SEDIMENT AND EROSION CONTROL CHECKLIST

| Project Name: | Lakeforest Gateway | SEC Plan Number: | SEC-9940-2024 |

SWM PRELIMINARY PLAN REVIEW CHECKLIST

PRELIMINARY SEDIMENT & EROSION CONTROL PLAN

© 2025 VIKI MARYLAND, LLC
 DRAWN BY: AD
 DESIGNED BY: ID
 DATE ISSUED: 7/16/2024
 VIKI PROJECT: VM50089
 DRAWING NO.:
 SHEET NO.: PSEC-2

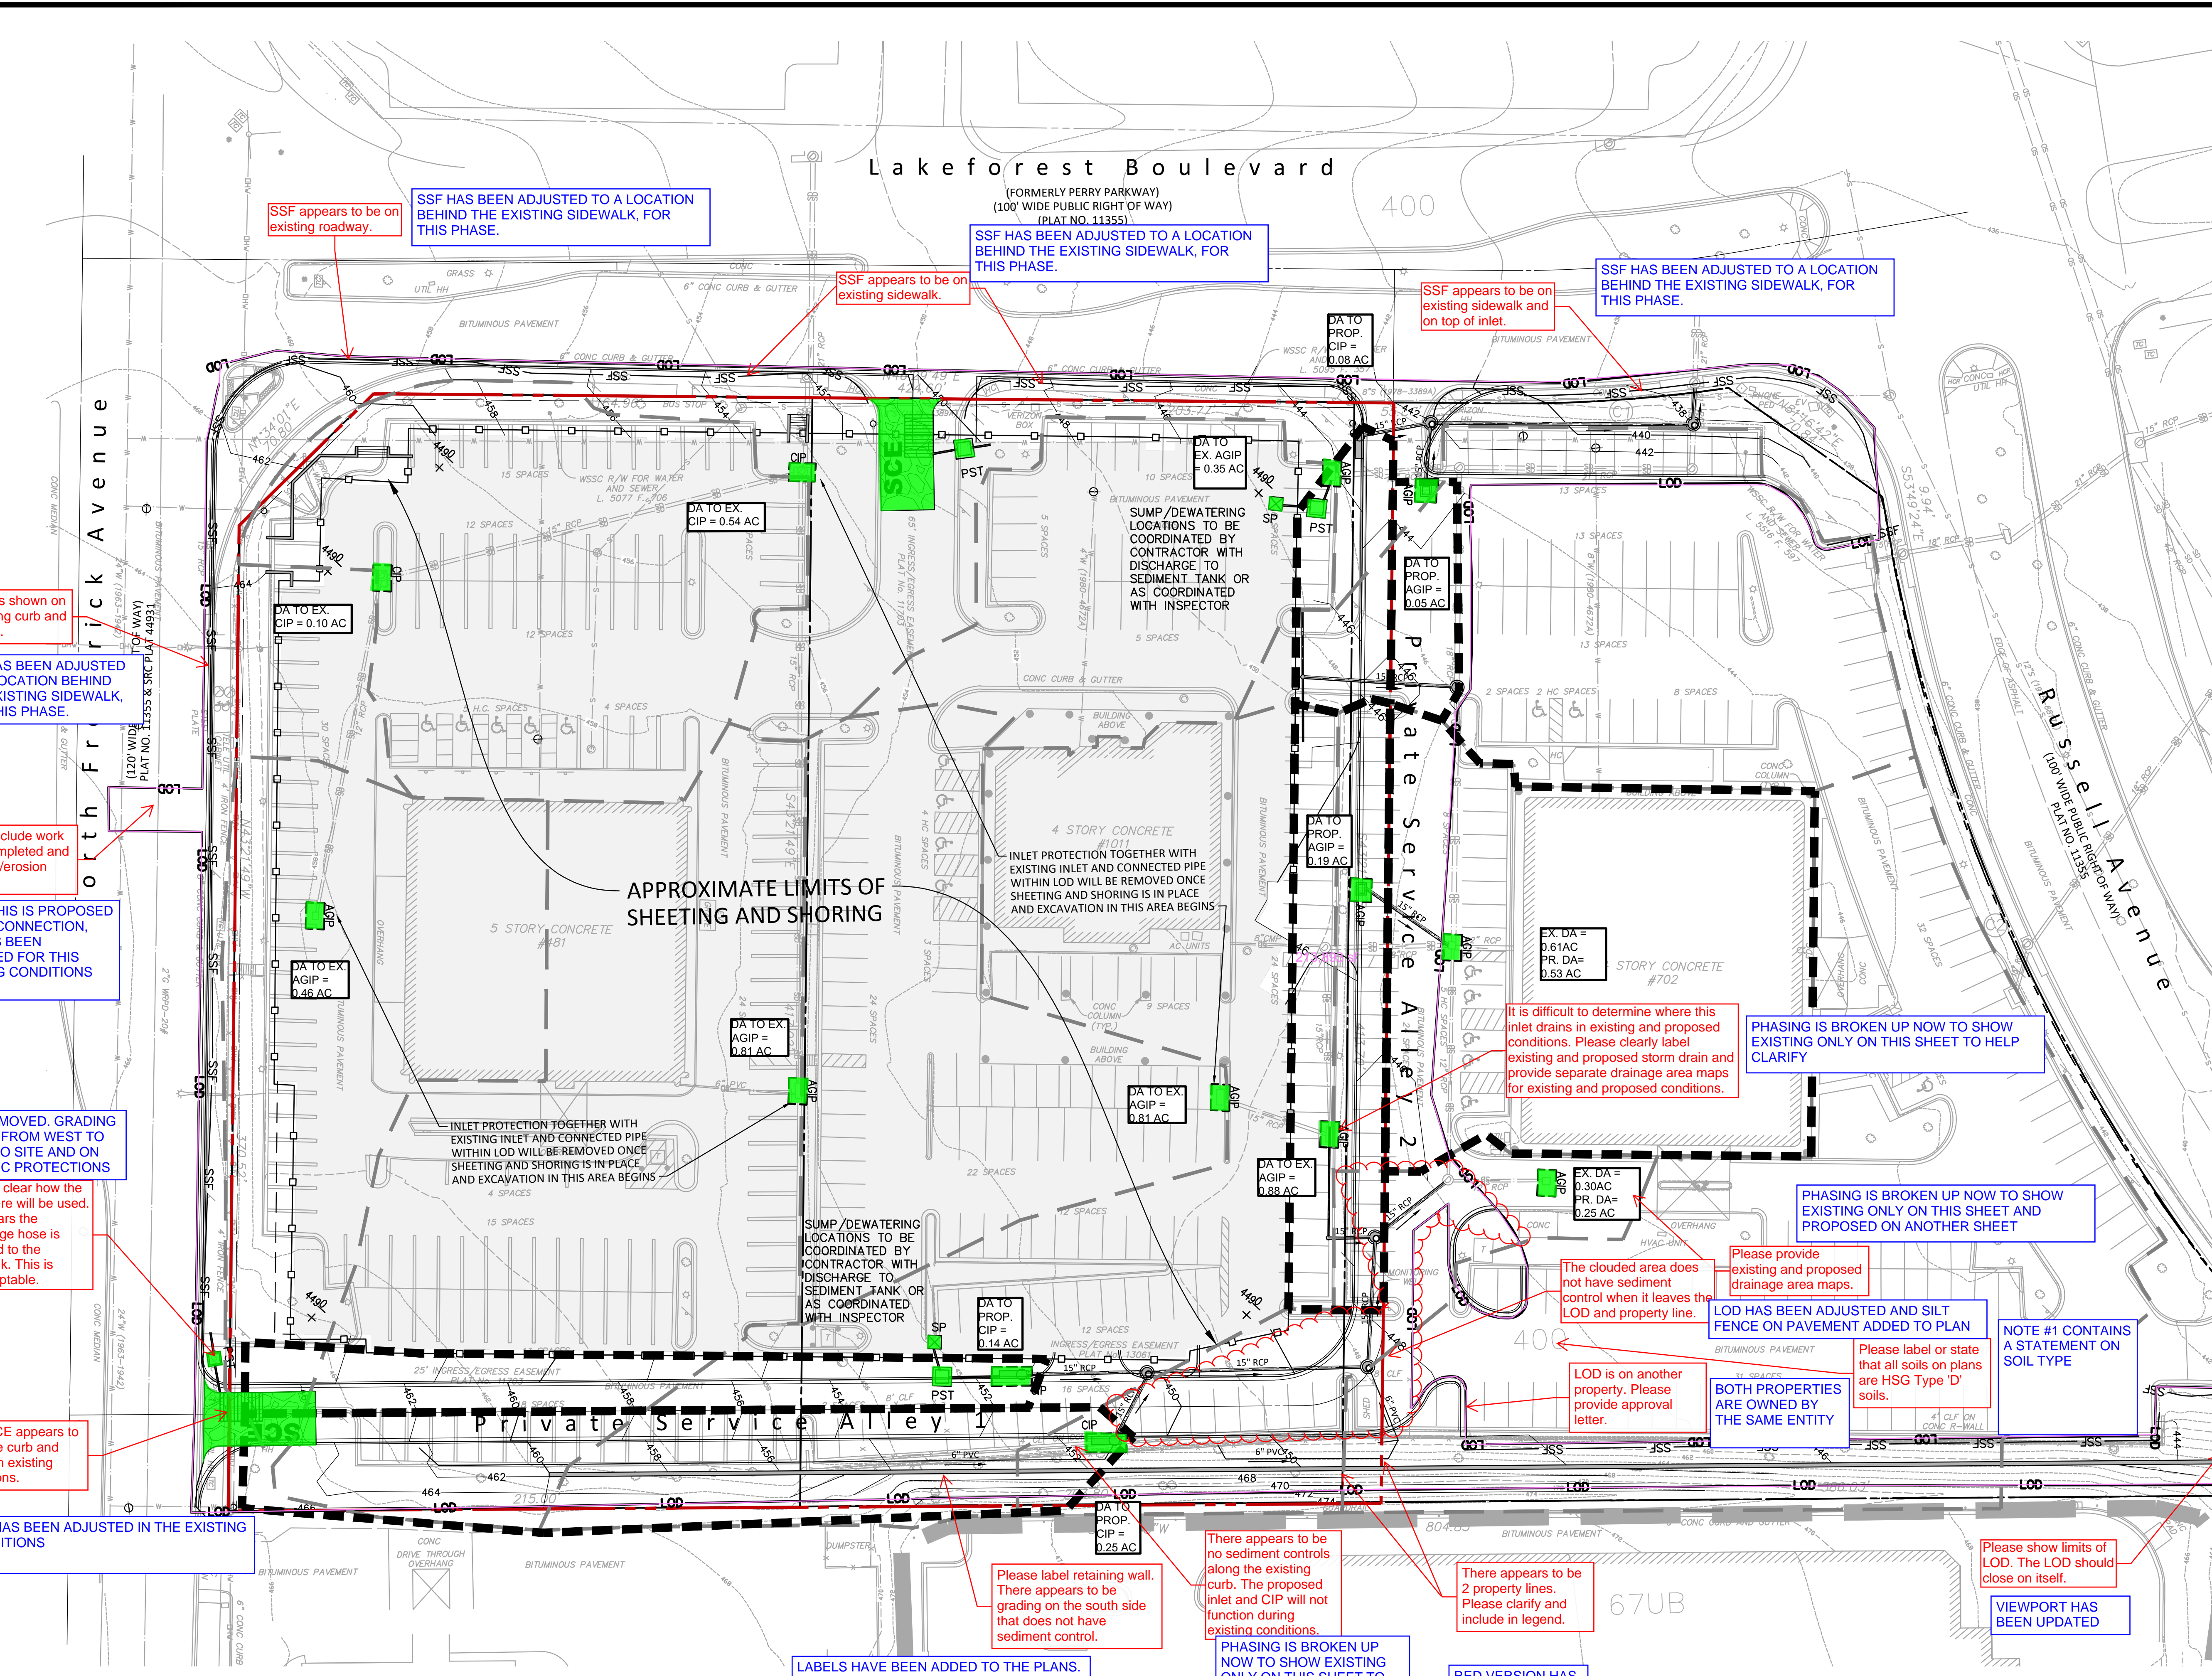
SSF appears to be on existing roadway.
 SSF HAS BEEN ADJUSTED TO A LOCATION BEHIND THE EXISTING SIDEWALK, FOR THIS PHASE.

SSF appears to be on existing sidewalk and on top of inlet.
 SSF HAS BEEN ADJUSTED TO A LOCATION BEHIND THE EXISTING SIDEWALK, FOR THIS PHASE.

SSF is shown on existing curb and gutter.

Please include work being completed and sediment/erosion controls.

It is not clear how the PST here will be used. It appears the discharge hose is directed to the sidewalk. This is unacceptable.

This SCE appears to straddle curb and gutter in existing conditions.

It is difficult to determine where this inlet drains in existing and proposed conditions. Please clearly label existing and proposed storm drain and provide separate drainage area maps for existing and proposed conditions.

PLEASE LABEL OR STATE THAT ALL SOILS ON PLANS ARE HSG Type 'D' soils.

LOD is on another property. Please provide approval letter.

Please show limits of LOD. The LOD should close on itself.

SSF HAS BEEN ADJUSTED TO A LOCATION BEHIND THE EXISTING SIDEWALK, FOR THIS PHASE.

SSF HAS BEEN ADJUSTED TO A LOCATION BEHIND THE EXISTING SIDEWALK, FOR THIS PHASE.

SINCE THIS IS PROPOSED WATER CONNECTION, LOD HAS BEEN ADJUSTED FOR THIS EXISTING CONDITIONS PHASE

PST REMOVED. GRADING FLOWS FROM WEST TO EAST. TO SITE AND ON SITE SEC PROTECTIONS

SCE HAS BEEN ADJUSTED IN THE EXISTING CONDITIONS

PHASING IS BROKEN UP NOW TO SHOW EXISTING ONLY ON THIS SHEET TO HELP CLARIFY

PHASING IS BROKEN UP NOW TO SHOW EXISTING ONLY ON THIS SHEET TO HELP CLARIFY

PHASING IS BROKEN UP NOW TO SHOW EXISTING ONLY ON THIS SHEET AND PROPOSED ON ANOTHER SHEET

LOD HAS BEEN ADJUSTED AND SILT FENCE ON PAVEMENT ADDED TO PLAN

BOTH PROPERTIES ARE OWNED BY THE SAME ENTITY

LABELS HAVE BEEN ADDED TO THE PLANS, ONE FOR THE EXISTING RETAINING WALL AND ONE ON THE PROPOSED WALL SHOWN ON THE NEXT PHASE.
